Bill Center Testimony re Wilson Estates, before the Board of Supervisors, October 22, 2013

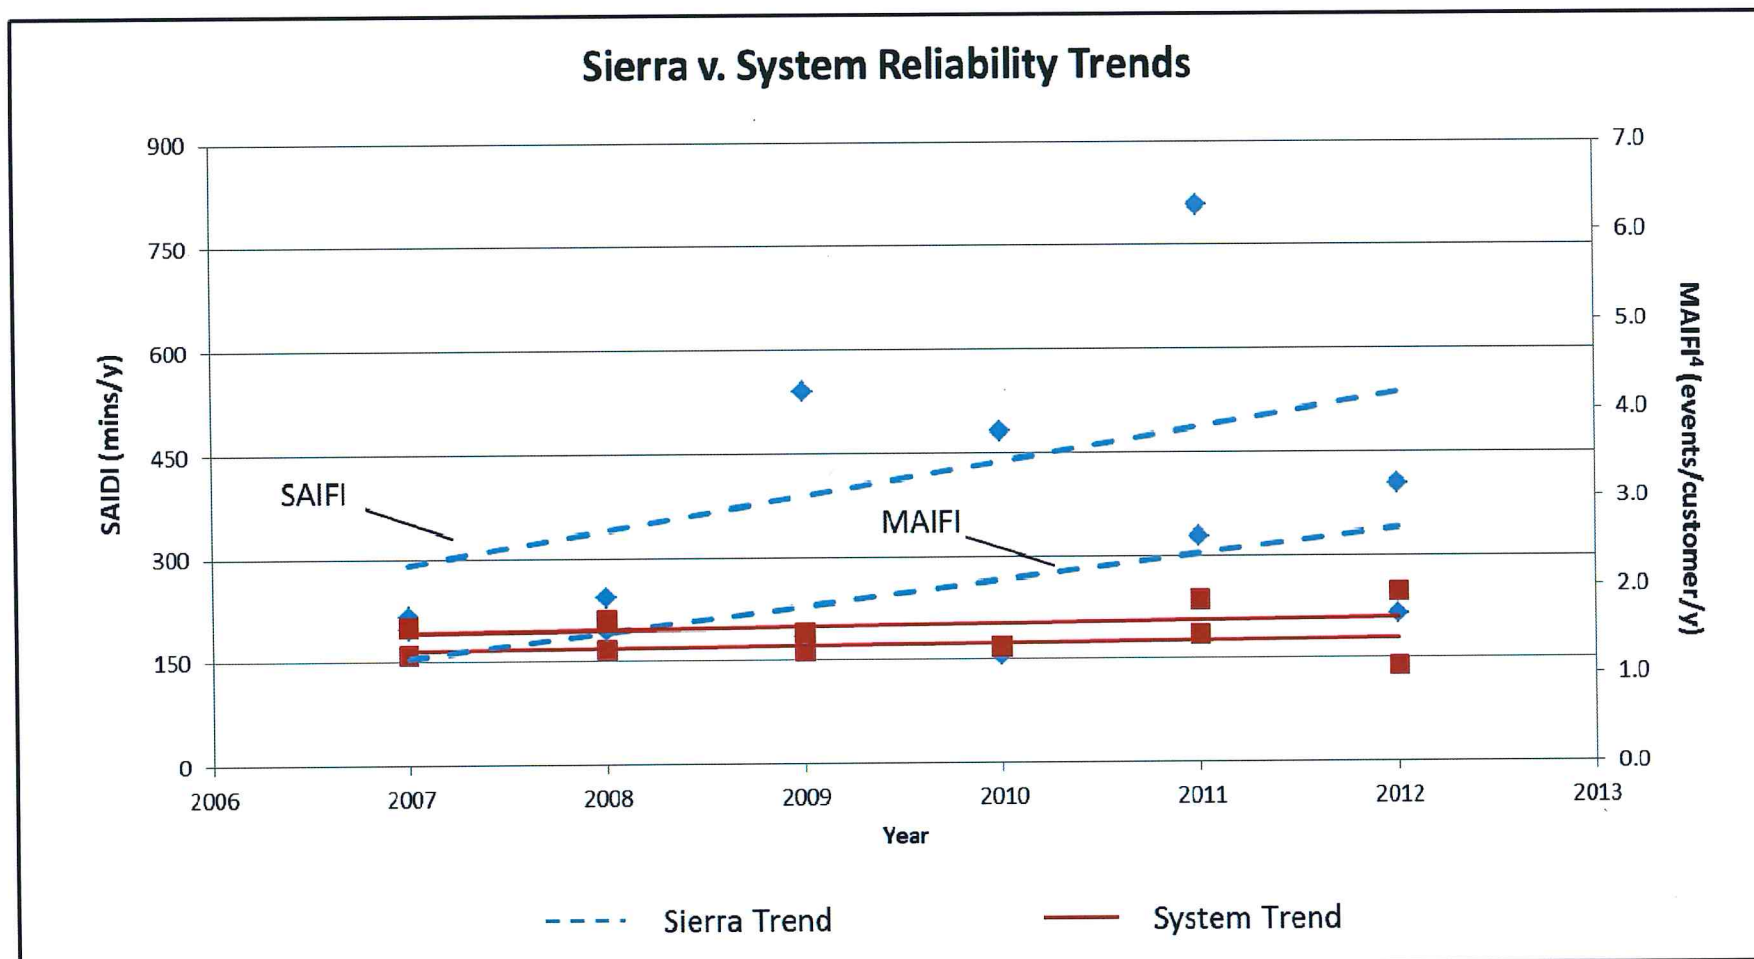
Note: Despite PG&E Efforts, Load growth around Hwy 50 & 80 corridor has surpassed infrastructure development. Enough time need to be given to PG&E to upgrade the electric infrastructure.
